ADDENDUM 1 (PENDING DSA APPROVAL)

PROJECT: **Santa Ana College**
 Science Center

DATE: 8/23/2017

DSA File No.: 30-C2
DSA Applications No.: 04-115788
HGA Commission No.: 3584-001-00

4 EXTERIOR HEAD DETAIL CURTAINWALL (A473)
 1 1/2" = 1'-0"

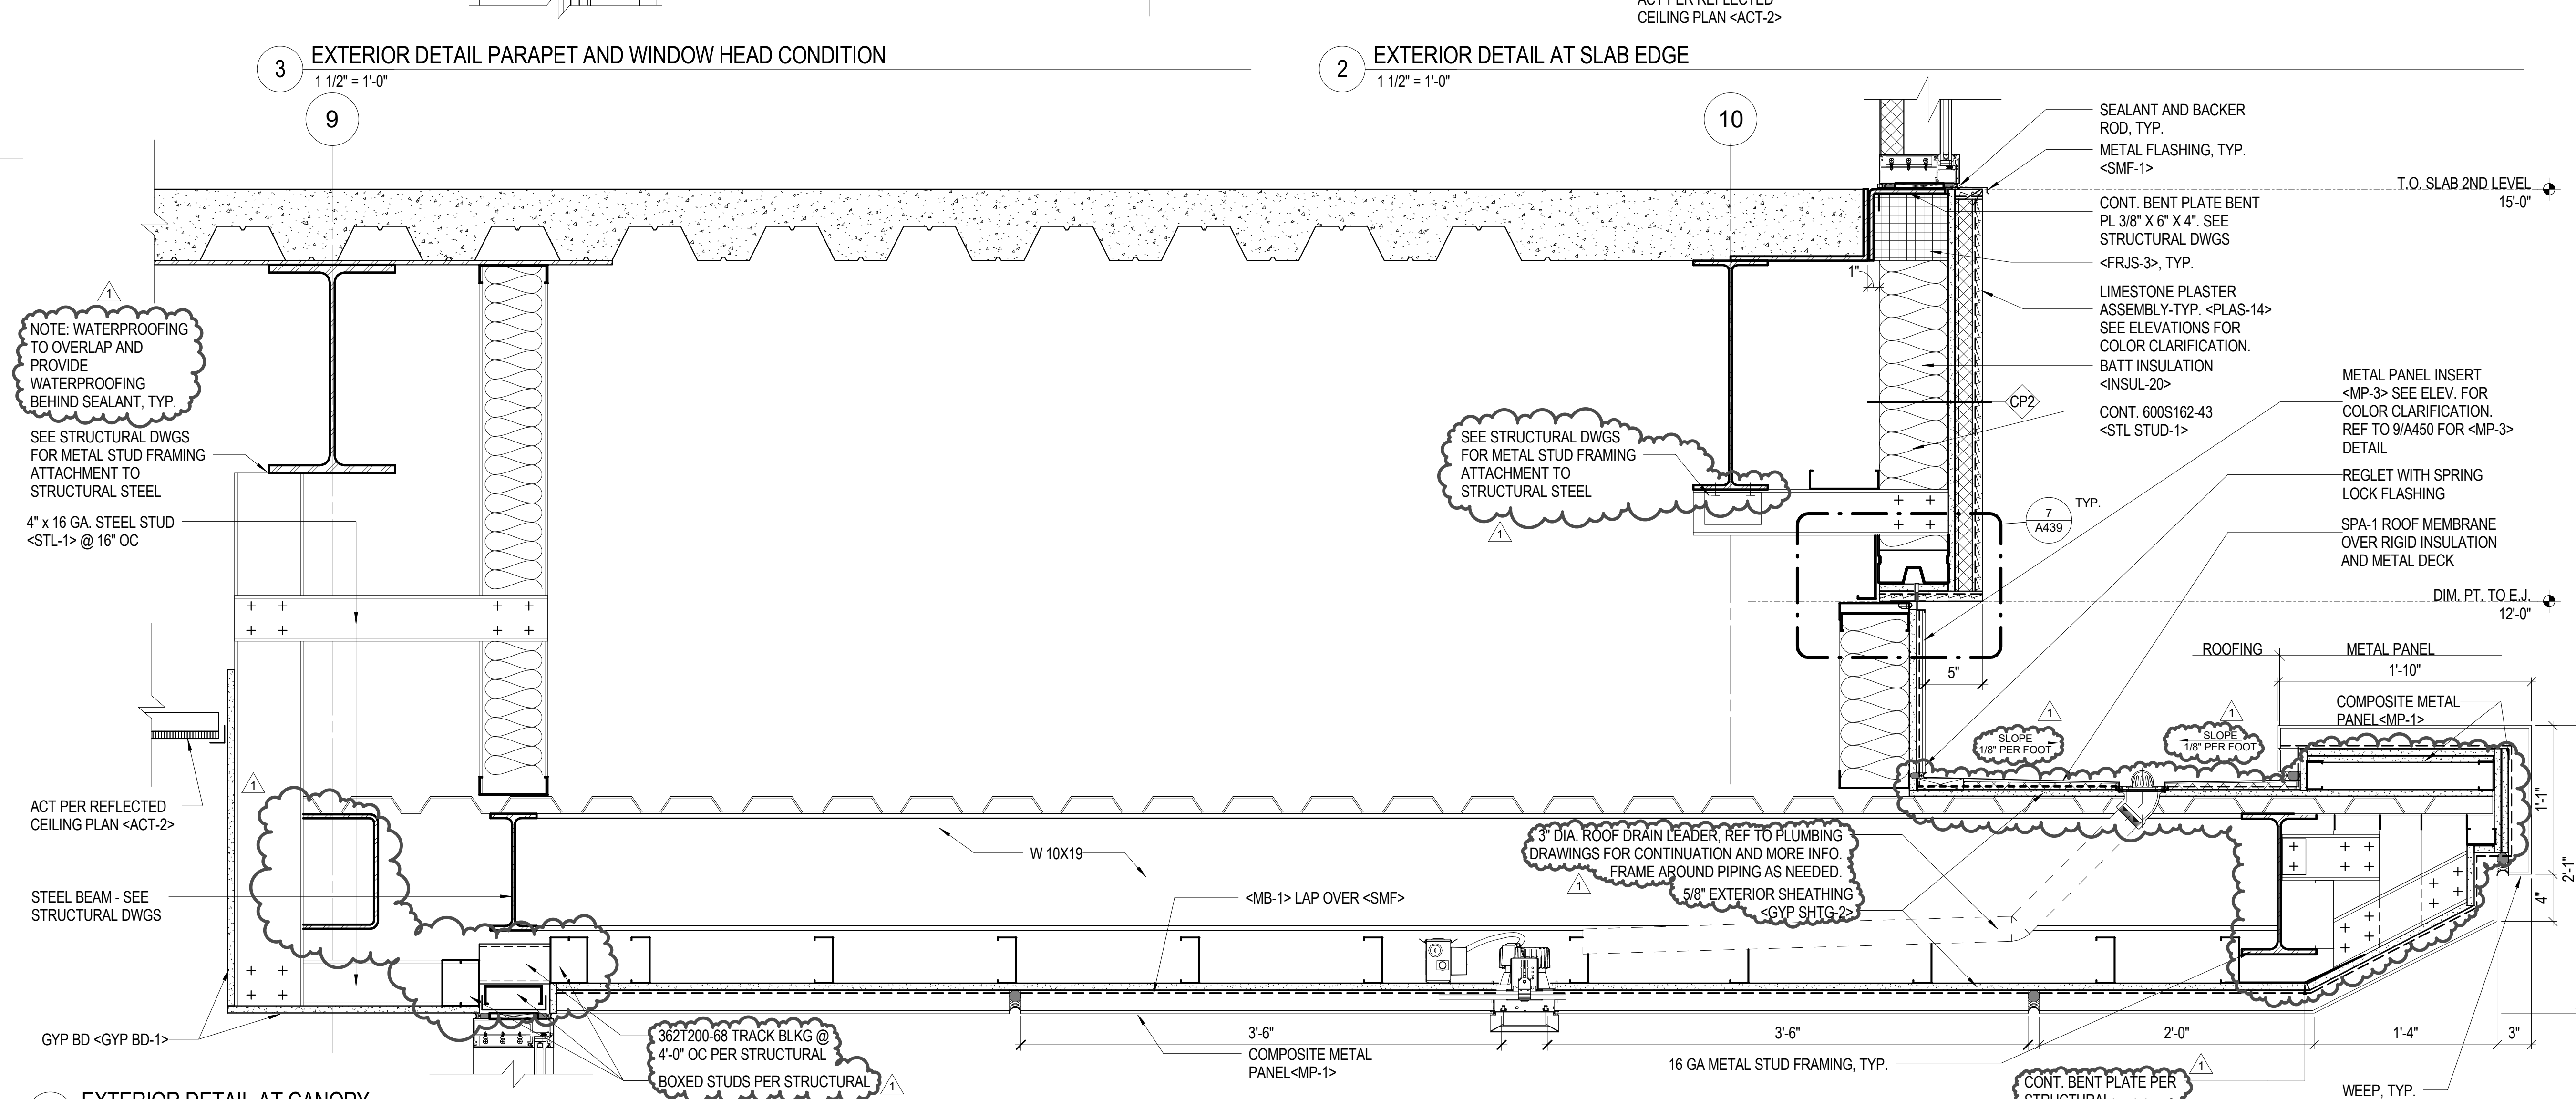
- Gutter removed from roof at north canopy at Details 1.
- Framing at canopy revised to match structural drawings at Details 1 and 4.
